SERVICE BULLETIN

APPLICABILITY: 2015 Legacy and Outback Models

NUMBER: 10-80-14

SUBJECT: Whistling Sound from Side Dash Vents

Side dash vent shown in almost fully closed position

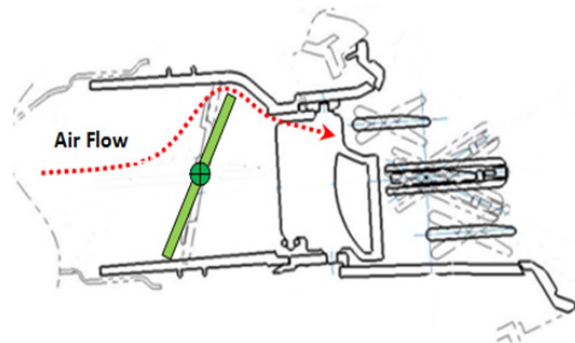
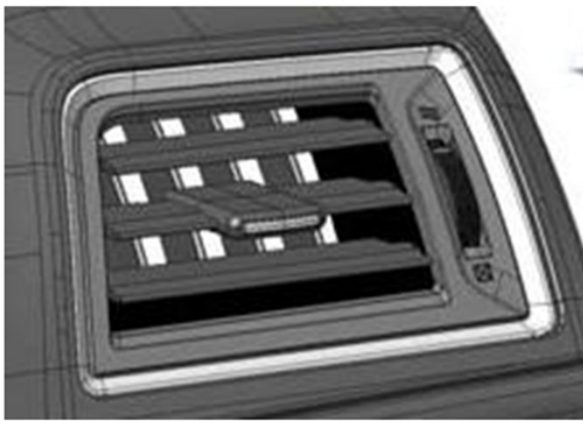
This bulletin provides a service procedure to address a customer concern of a whistling sound coming from the side dash vents when their air flow is adjusted to almost the fully closed position.
